Livestock Plaza/Sheep Barn

Addendum Issue Date: 8/8/24

The following changes, revisions, or clarifications shall be made to the drawing documents.:

SITE GRADING & UTILITIES

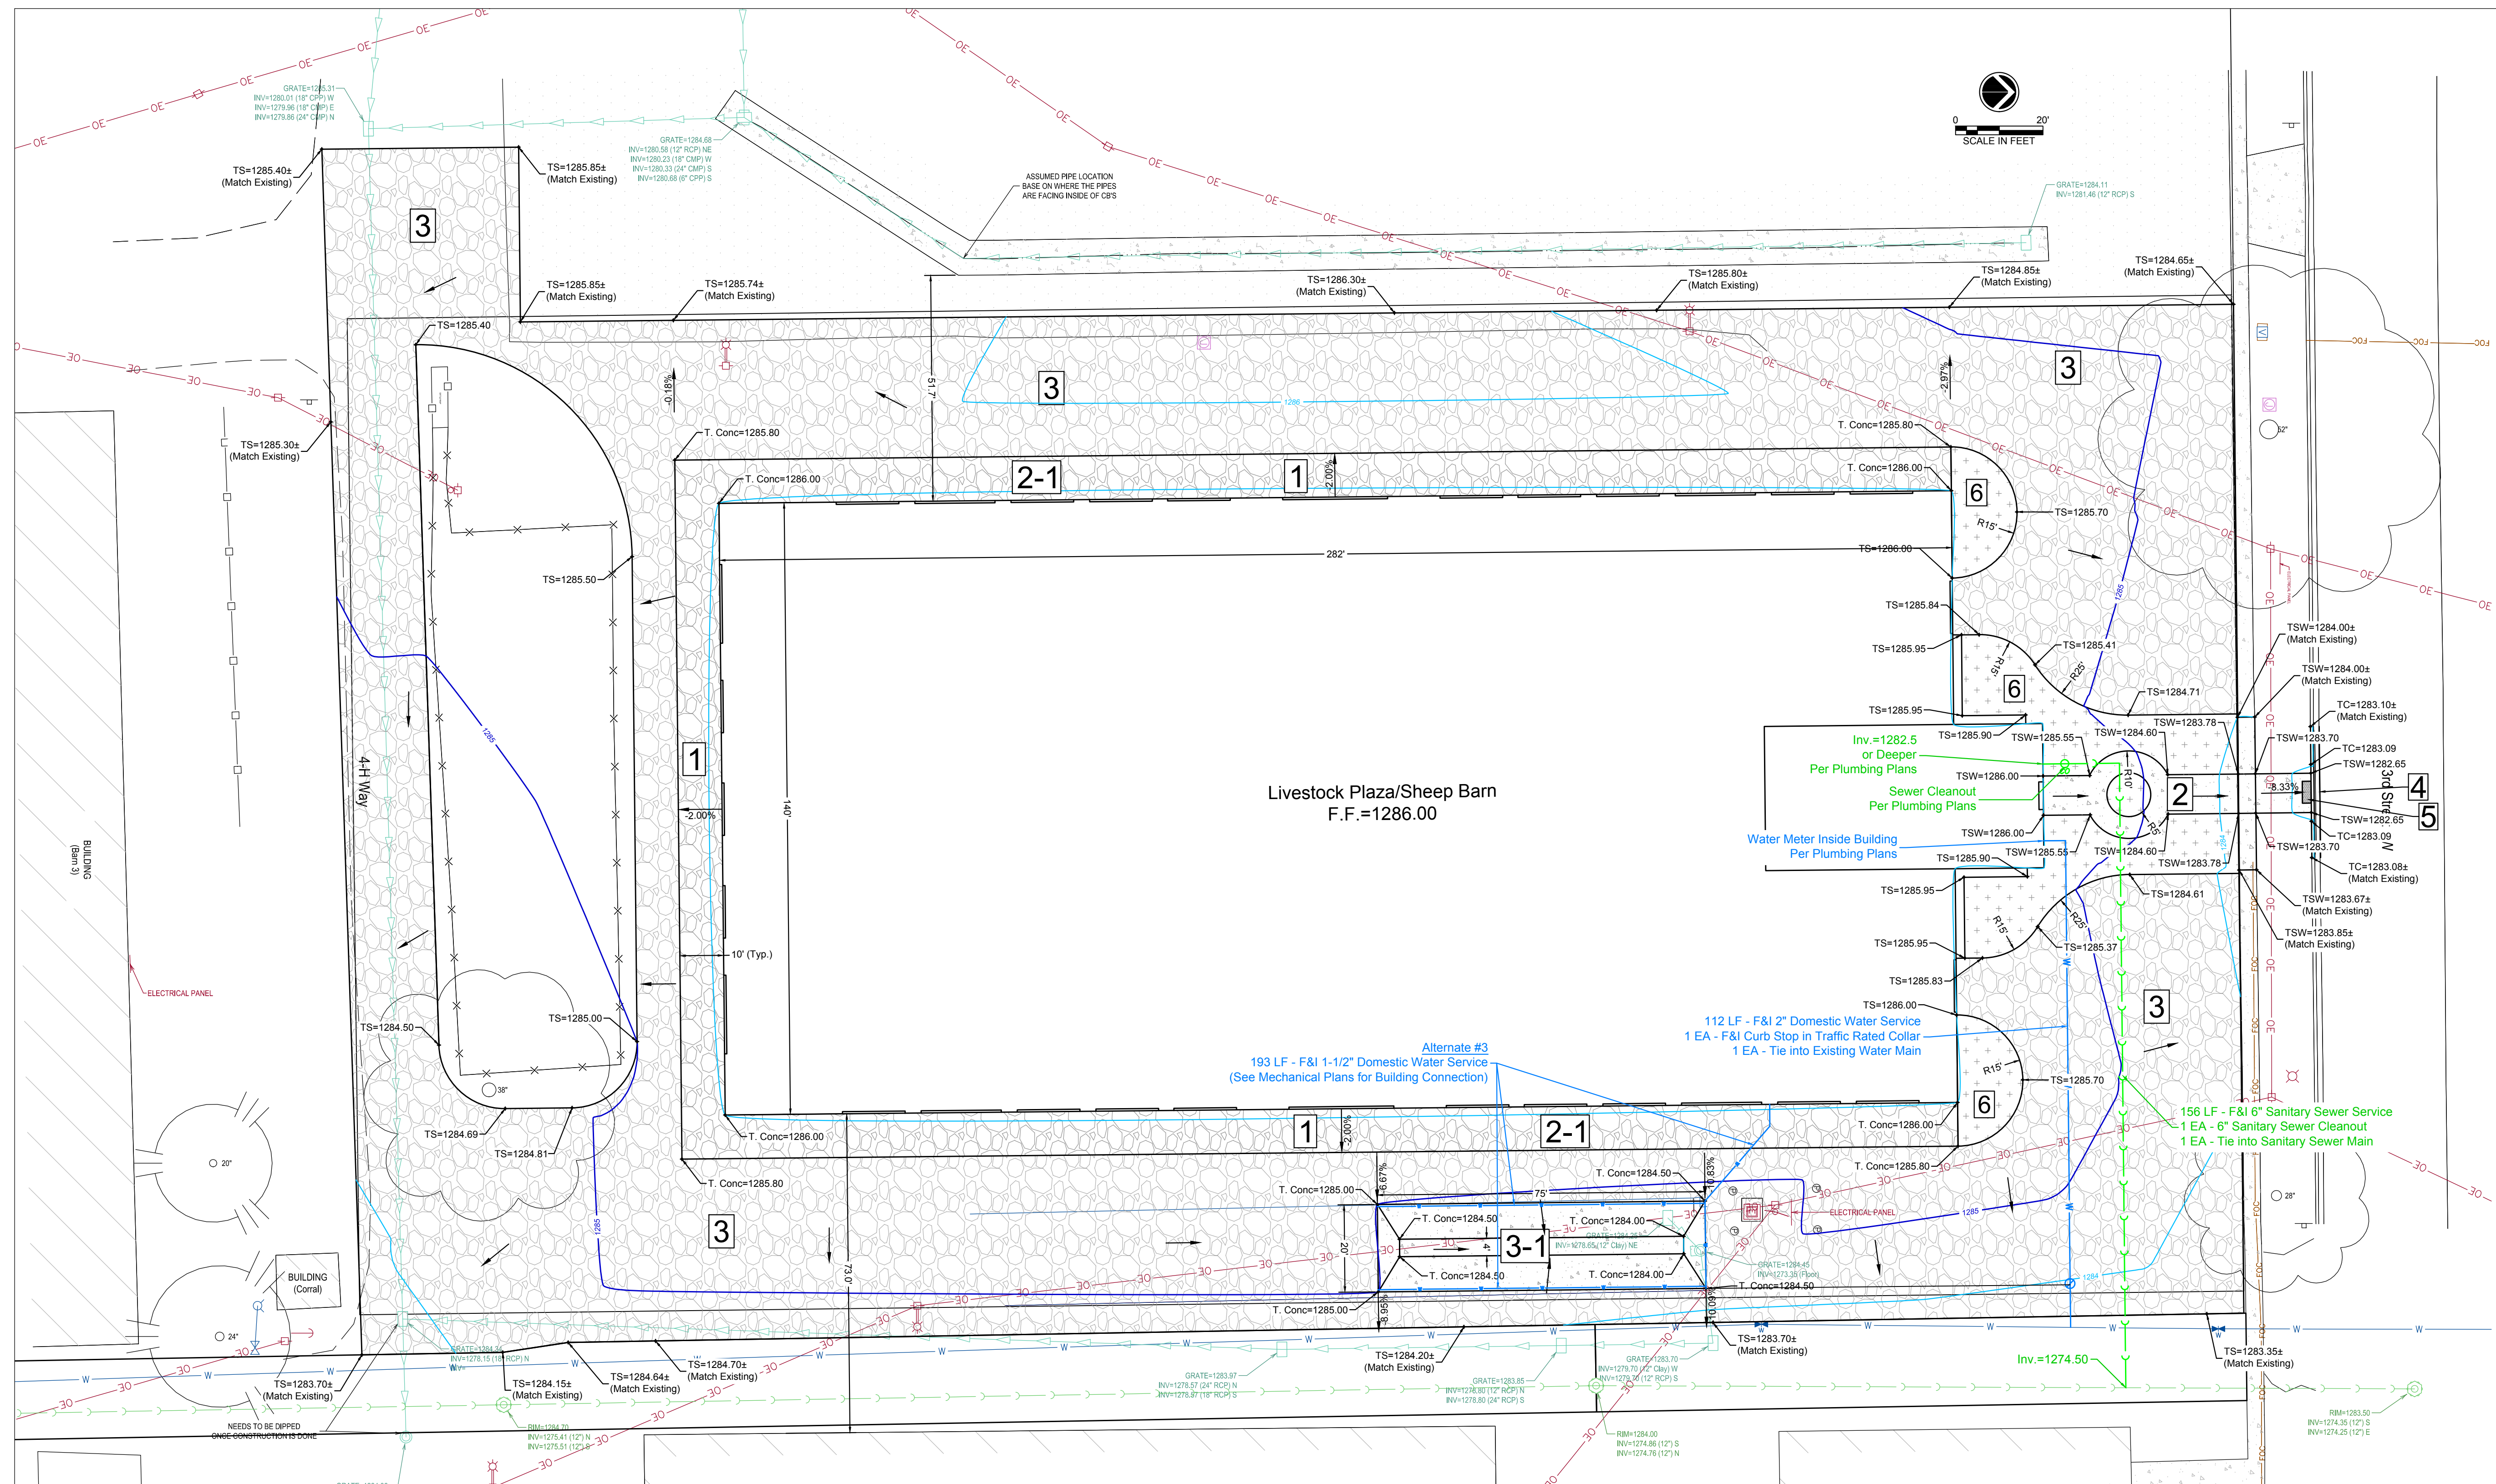
C5.1 - Site Grading & Utilities

- Changed 1” Domestic Water Service to 2” Domestic Water Service
- Added Alternate #3 Quantity for 1-1/2” Domestic Water Service to Wash Bay
- Added Landscaping (By Others) to Surfacing Legend

SHEET NAME:
BUILDING RELOCATION SITE PLAN

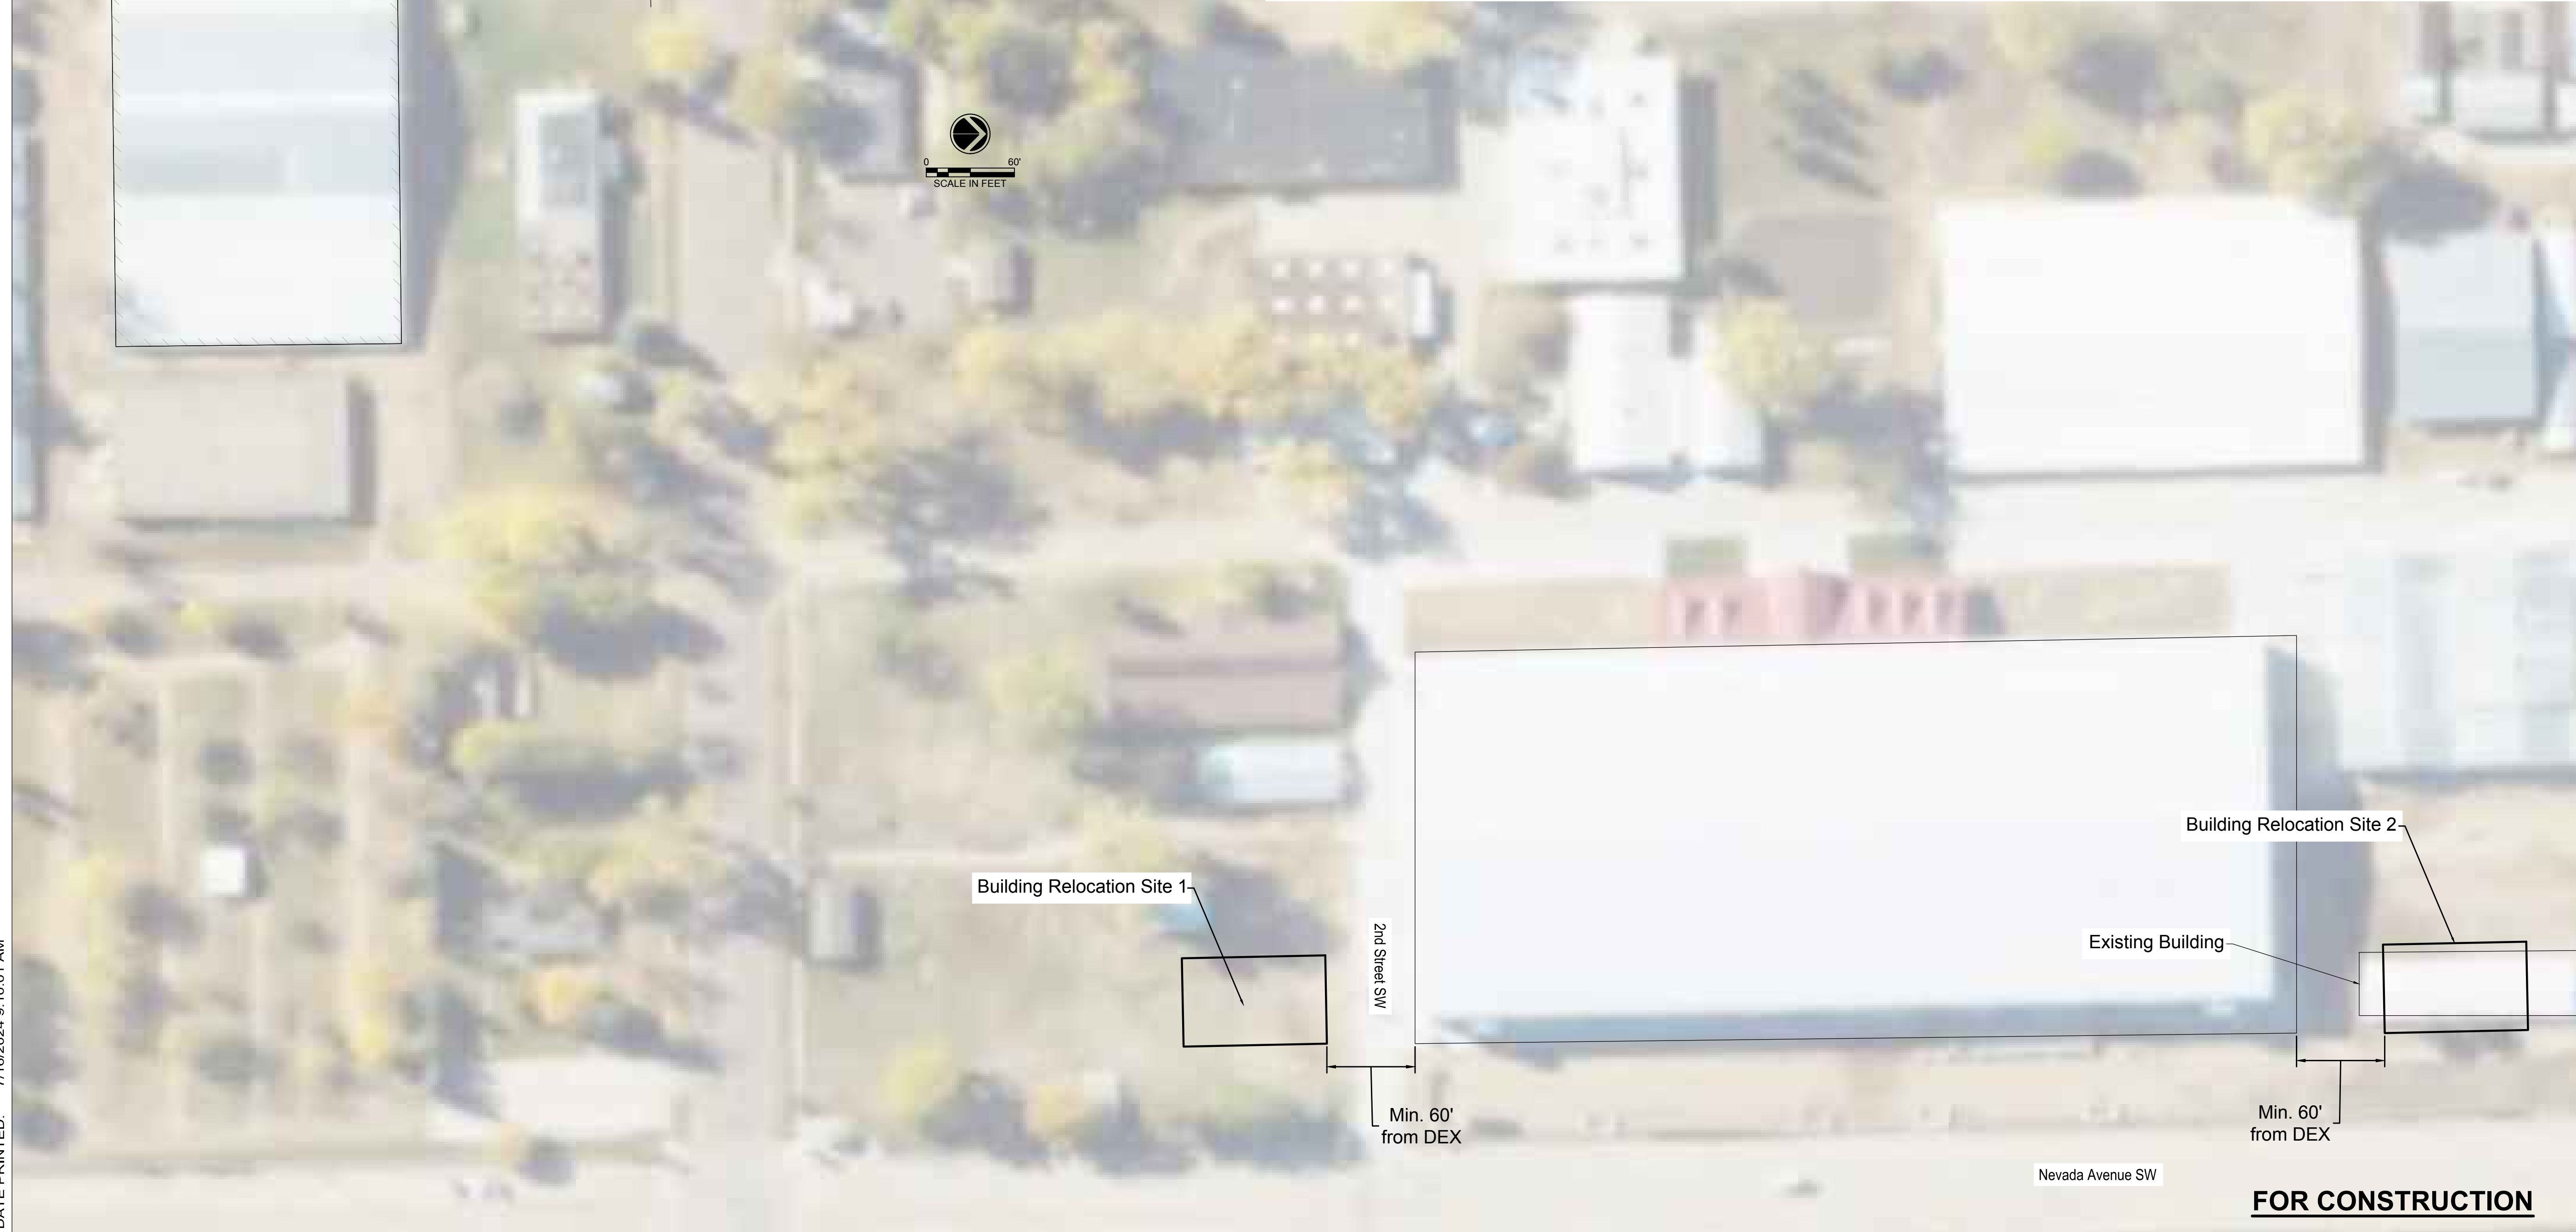
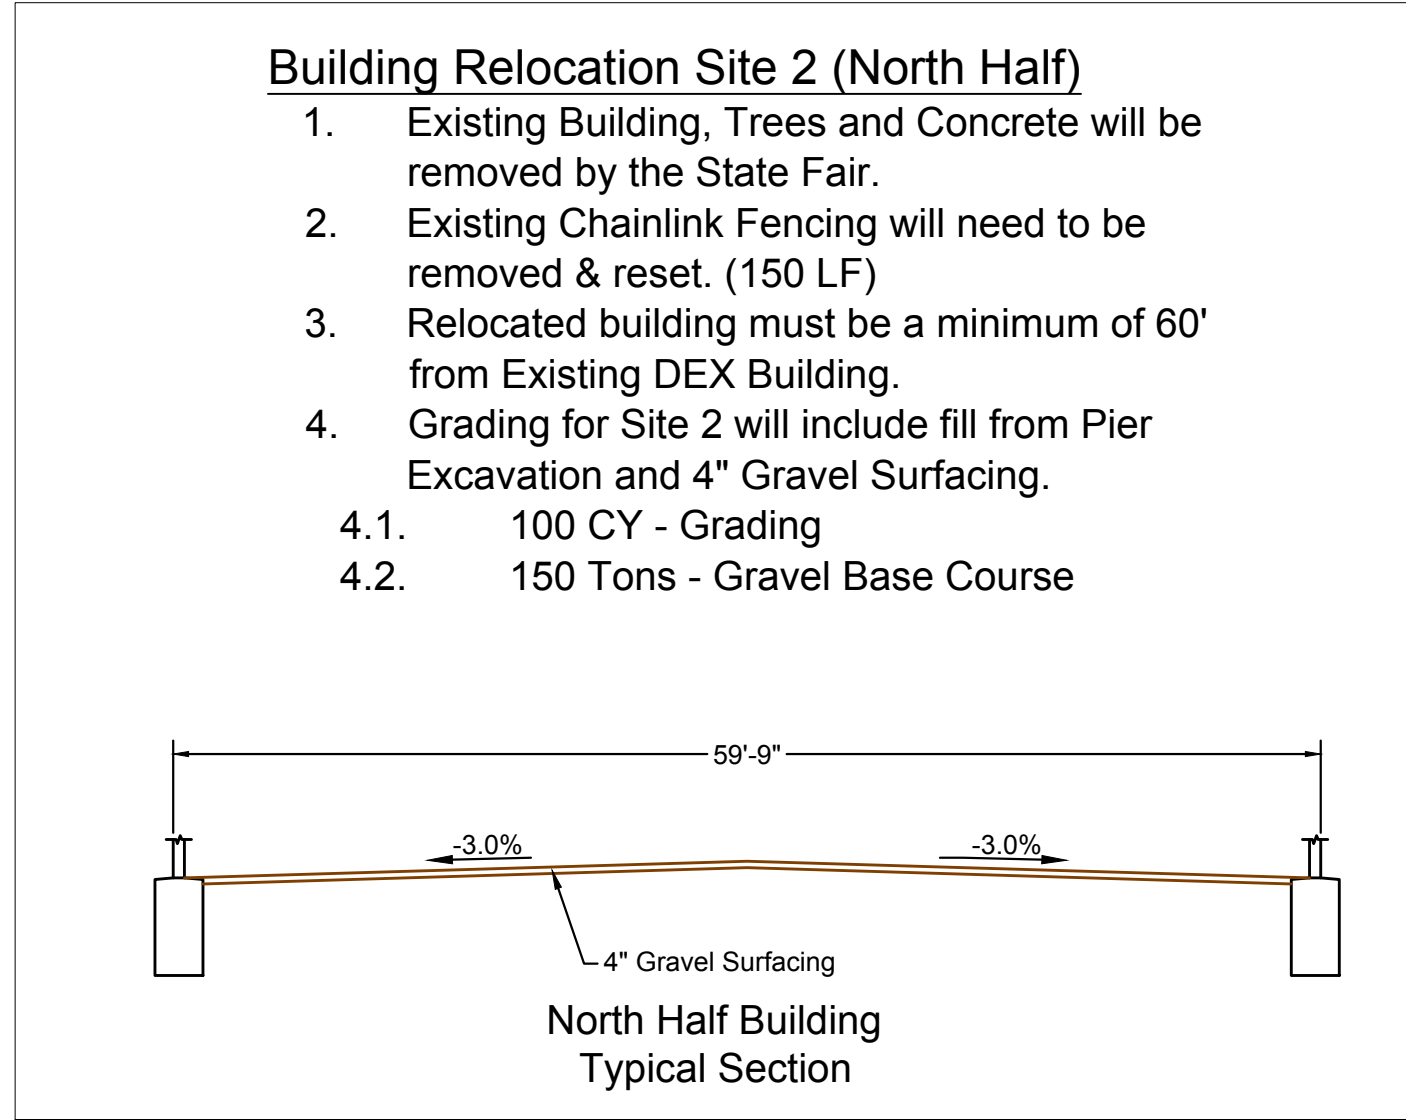
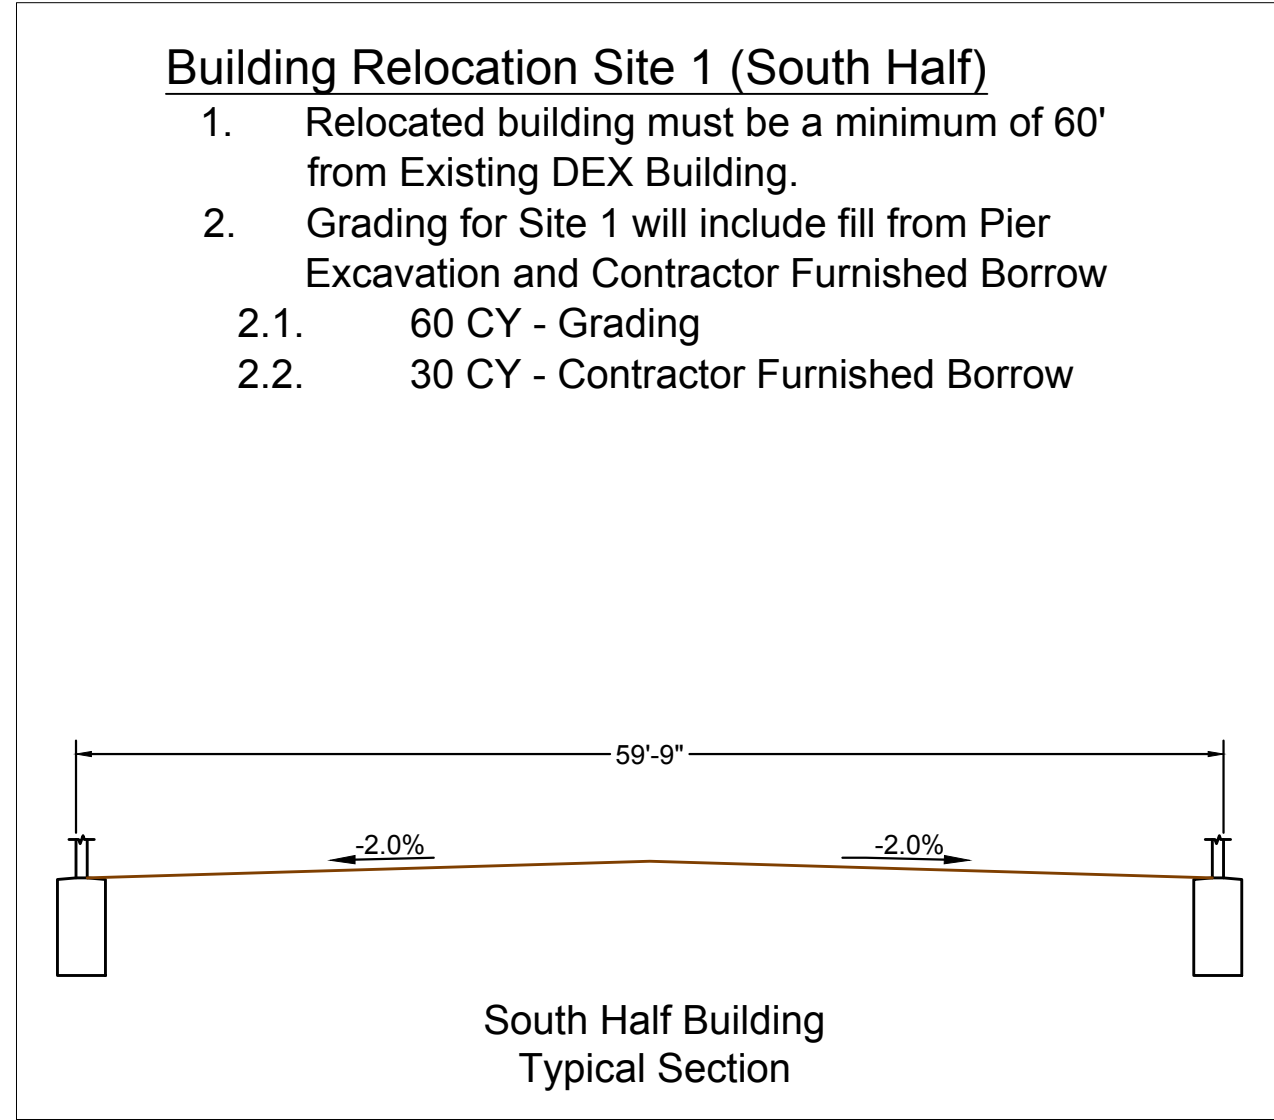
R-C1.1 - Building Relocation Site Plan

- Added Notes & Typical Sections for Building Relocation Sites
